#### CITY OF ALBUQUERQUE

RE: Bubba's 33 10000 Coors Bypass NW Grading and Drainage Plan Engineer's Stamp Date: 03/19/21 Hydrology File: B14D004H

- PO Box 1293 Based upon the information provided in your submittal received 03/22/2021, the Grading & Drainage Plan **is not** approved for Building Permit. The following comments need to be addressed for approval of the above referenced project:

**GRADING AND** DRAINAGE PLAN

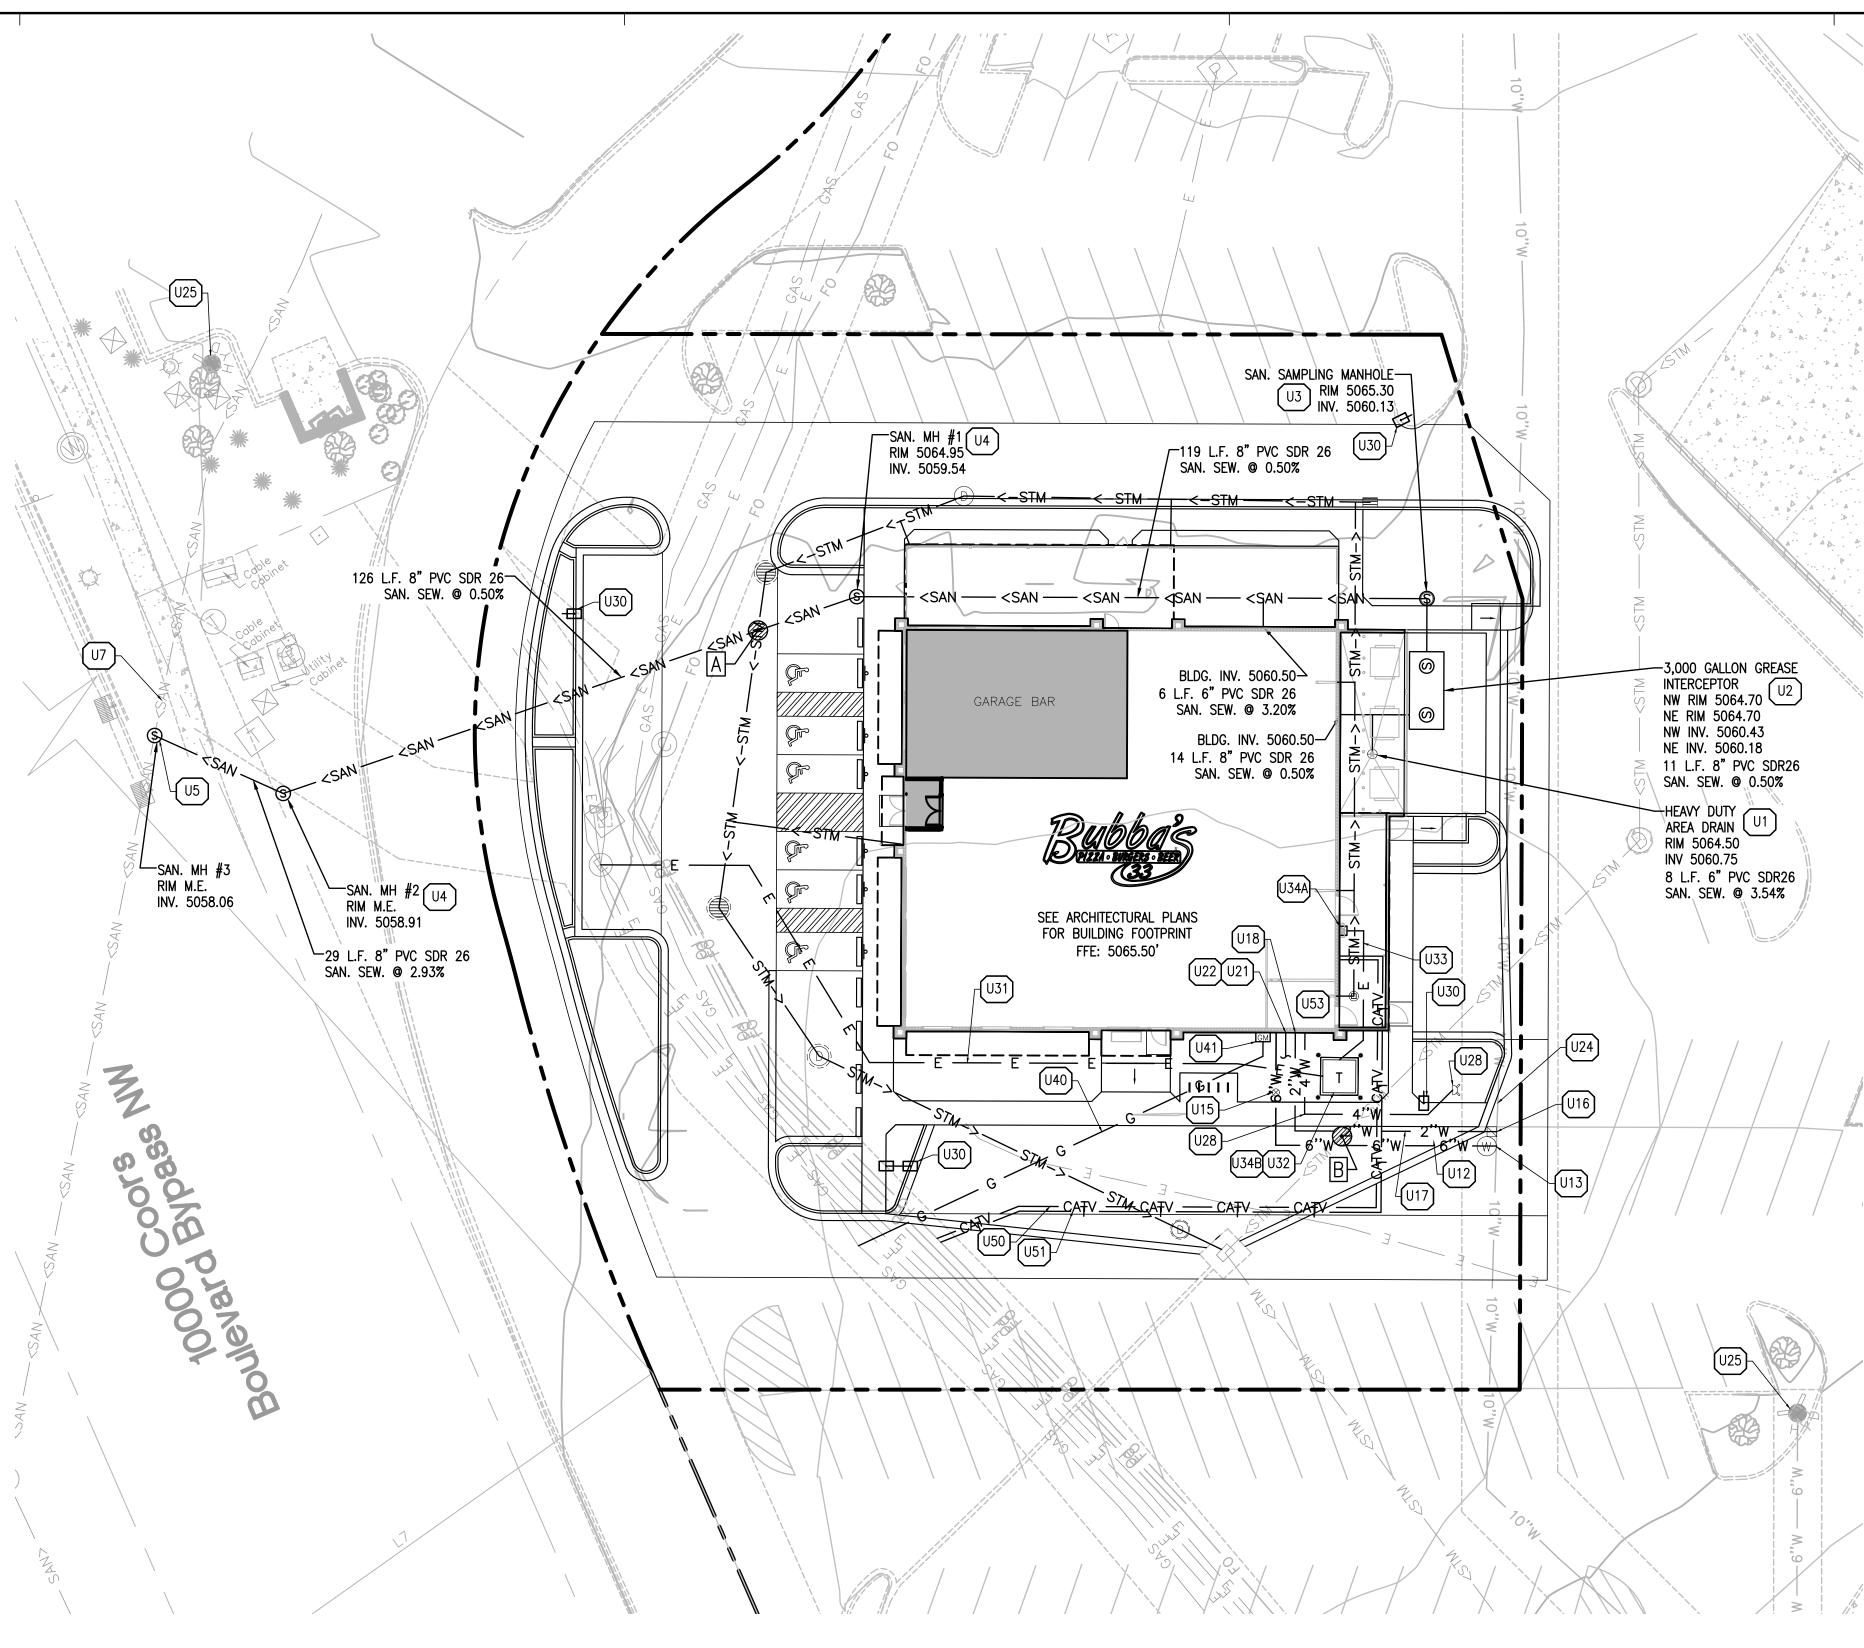
- Albuquerque 1. Please use the procedure for 40 acre and smaller basins as outlined in Development Process Manual (DPM) (signed 06/08/20) Article 6-2(a). Please provide both the existing conditions and proposed conditions for the 100-year 6-hour storm event.

- 2. Provide management onsite for the Stormwater Quality Volume (SWQV) in accordance with the new drainage ordinance, § 14-5-2-6 (H) enacted 10/2/18 (Council Bill C/S O-18-2) and as outlined in DPM (signed 06/08/20) Article 6-12 Stormwater Quality and Low-Impact Development for the sizing calculations. Since this is site is a redevelopment the SWQ pond volume will be 0.26 \* new impervious area (new paving, sidewalks, and building) (sf) \* 1/12. If you are planning to provide for the SWQ volume, please show the top and bottom of the ponds along with the volume for each pond within the landscape areas. The onsite drainage should be directed to these ponds via curb cuts prior to either being collected in the existing inlet or leaving the site for the public drainage system. If you are going to not provide for the SWQ volume within the landscape areas, then you will need to add a statement, "The Owner has elected to pay for the Stormwater Quality Volume. The Payment-in-lieu will be \$8 / CF \* SWQ volume (CF) = \$ XX."

- 3. Please show the edge of saw cut of the existing pavement and label along this, "Match existing grades". I can see this on the Site Plan but I need the saw cut line here as well.
